**Car Stereo
Service Bulletin**

Model: XR-U220

No.262

Subject: Tuner Audio Level May Be Lower Than Audio Level From The Tape and CD

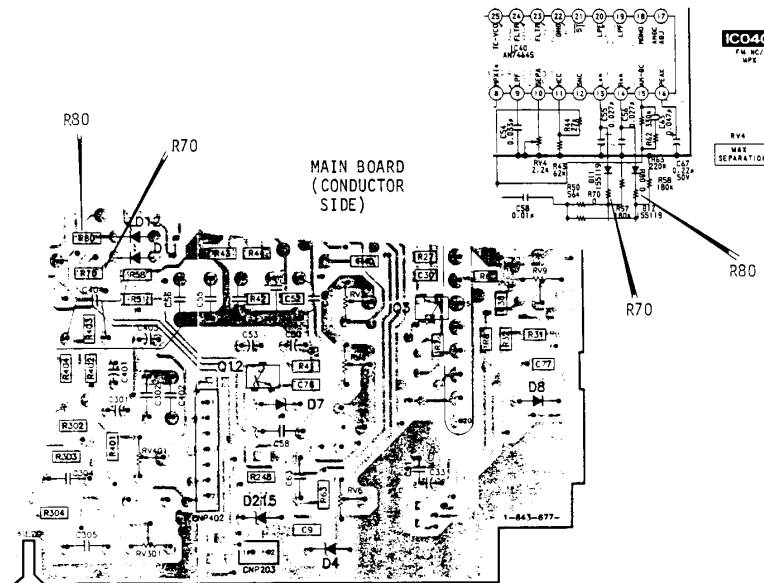
Symptom:
(52)

The audio level when listening to the tuner may be lower than the audio level when listening to a tape or CD.

Measure the value of resistors R-70 and R-90 in the tuner section of the Main Board. If the values of these resistors are different than the values specified below, replace them with the correct resistors:

REFERENCE NUMBER	DESCRIPTION	PART NUMBER
R-70, R-80	RESISTOR, 0 OHM	1-216-295-00
